Part 5 Application **ACCESS REPORT**

Reference Number: 22412

Stanton Dahl Architects

15-17 Combles Parade & 2-4 Hamel
Road. Matraville NSW.

[Image description: Plan of the ground floor above shows the provision of Accessible parking spaces]

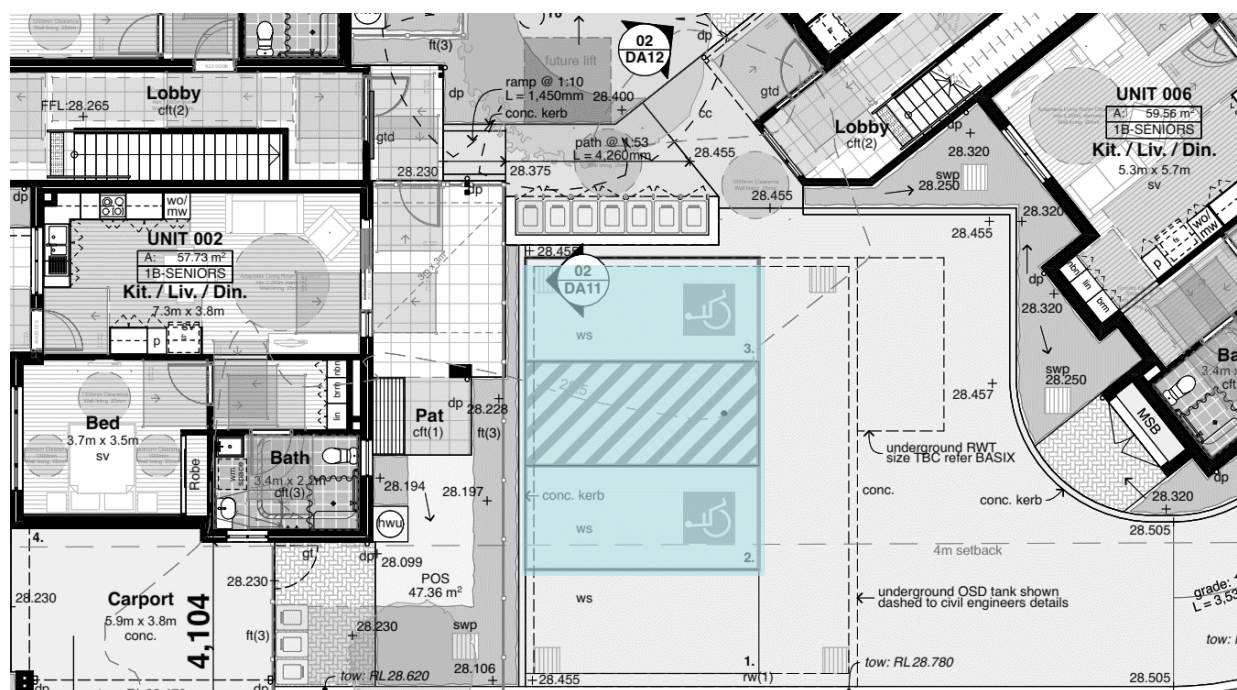
2 Accessible parking spaces have been provided for the requirements of Schedule 4 of State Environmental Planning Policy (Housing) 2021, Part 5 Housing for seniors and people with a disability

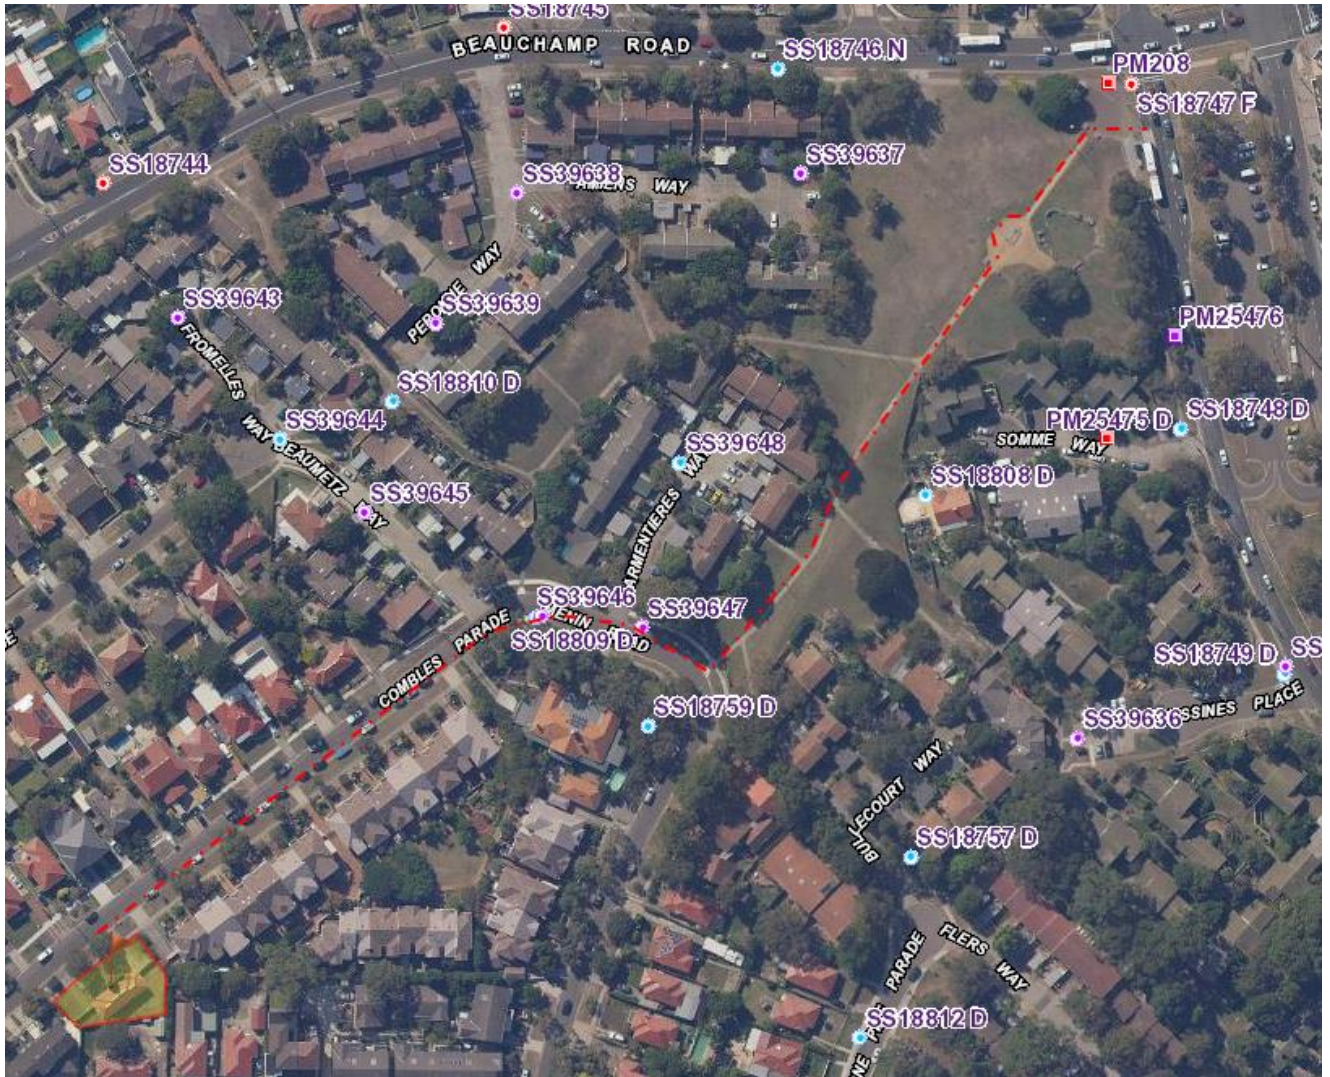
The distance tool by scaling off plans from site to the bus stop at Beauchamp Road shows a distance of 482M to the nominated bus stop. Due to the dimension being close to 400M we recommend reconfirmation by the Building surveyor on the distance.

The distance tool by scaling off plans from site to the bus stop at Anzac Parade shows a distance of 448M to the nominated bus stop. Due to the dimension being close to 400M we recommend reconfirmation by the Building surveyor on the distance

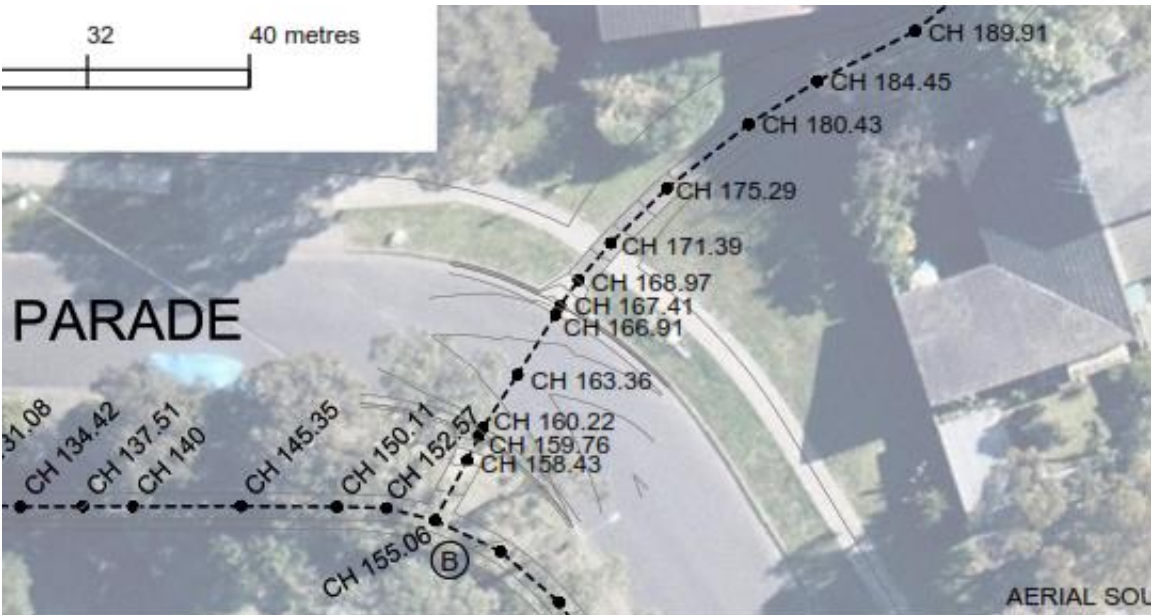
1:7 grades shown below to be rectified to provide max of 1:8 grade and kerb ramp to fully comply with AS1428.1

1:7 grade to be adjusted to a maximum of 1:8 grade.

Crossing across Beauchamp Road

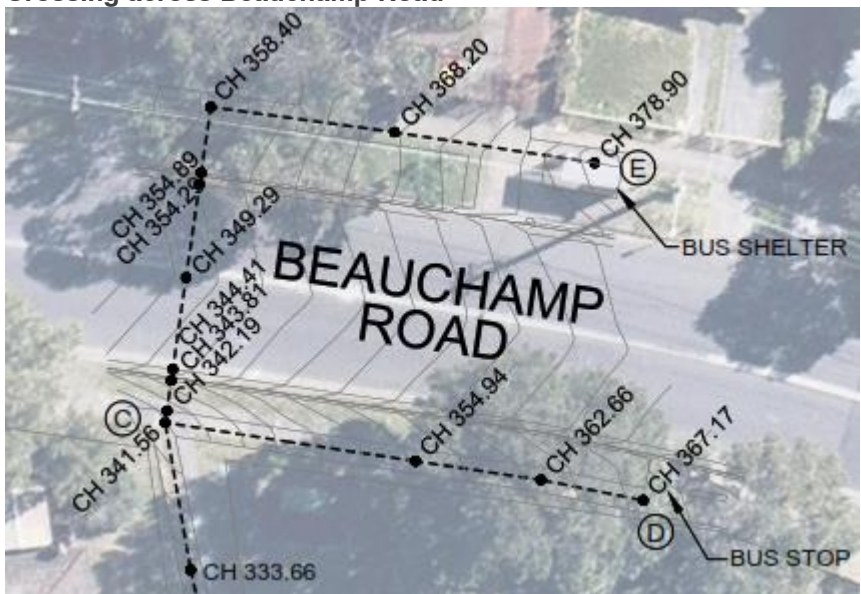
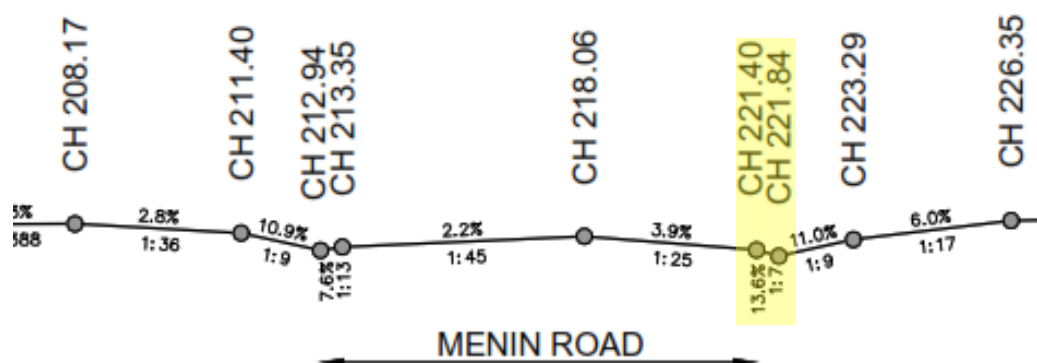
1:5 and 1:7 grades shown below to be rectified to provide max of 1:8 grade and kerb ramp to fully comply with AS1428.1

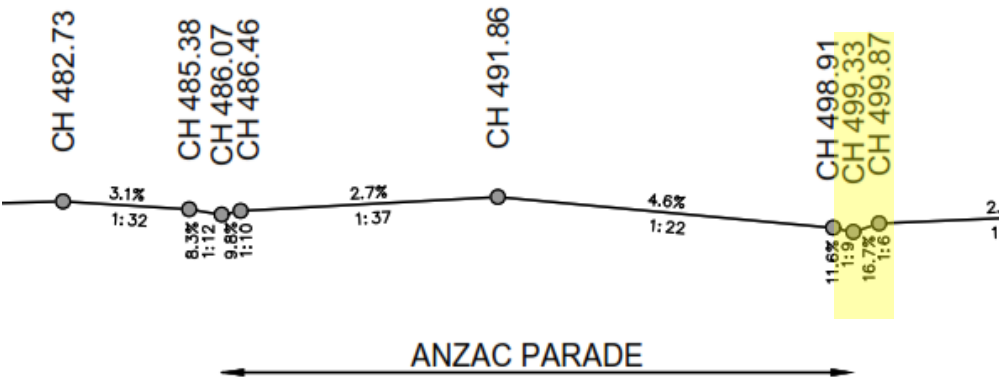
1:7 grade shown below to be rectified to provide max of 1:8 grade and kerb ramp to fully comply with AS1428.1
